Subject: **El Camino High School**
Drama Classroom Roofing – EDR 07
400 Rancho Del Oro Drive
Oceanside, CA 92057

OUSD Bid No.: 2021-21-24B

Project Number: 872-722

FINAL ADDENDUM (ADD1)

A. Roofing Membrane Installation: ECHS Drama Bldg. (Highlighted Below)

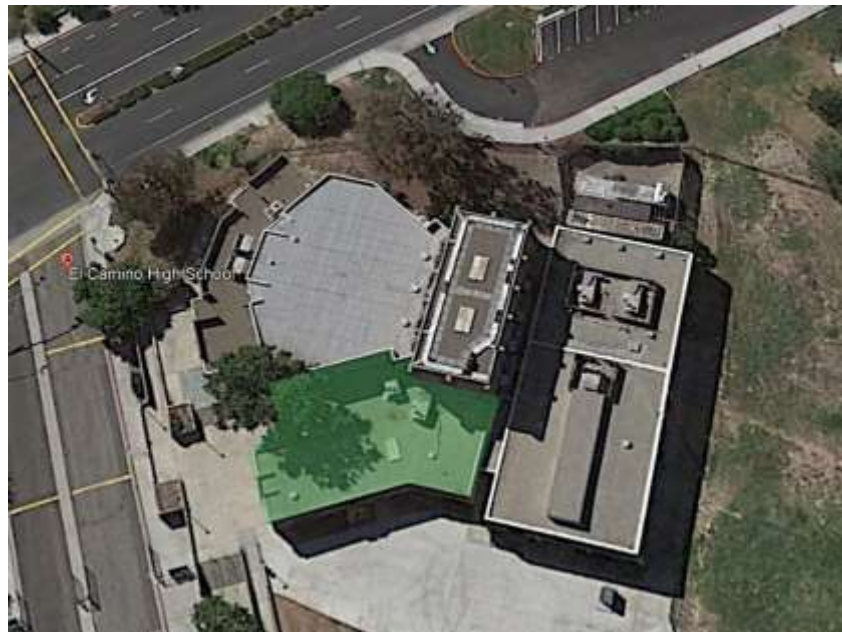
- A. Replace 072500, 073213, 074100, 075500, 075700 with the provided **074216**. Refer to revised specification attached via email and found at the below link.

1. All debris to be removed by Contractor (T&M).
2. Remove the existing roof system to the structural deck. Comply with abatement report.
3. Repair any damaged decking as required. Contractor to include 7% deck replacement in the base bid. If the amount of deck replacement exceeds 7%, the contractor is to receive a change order equal to the unit price for deck replacement per sq ft multiplied by the sq ft in excess of the base bid amount. If the amount of deck replacement is less than 7%, the contractor is to provide a credit to the District equal to the unit price of deck replacement per sq ft multiplied by the sq ft less than the base bid amount.

4. Mechanically fasten Type II base sheet with rosin paper.
5. Apply 80 mil SBS modified underlayment in hot asphalt at rate of 25 lbs per sq.
6. Apply dual fiberglass-reinforced SBS modified, UV Resistant cap sheet in hot asphalt at rate of 30 lbs per sq.
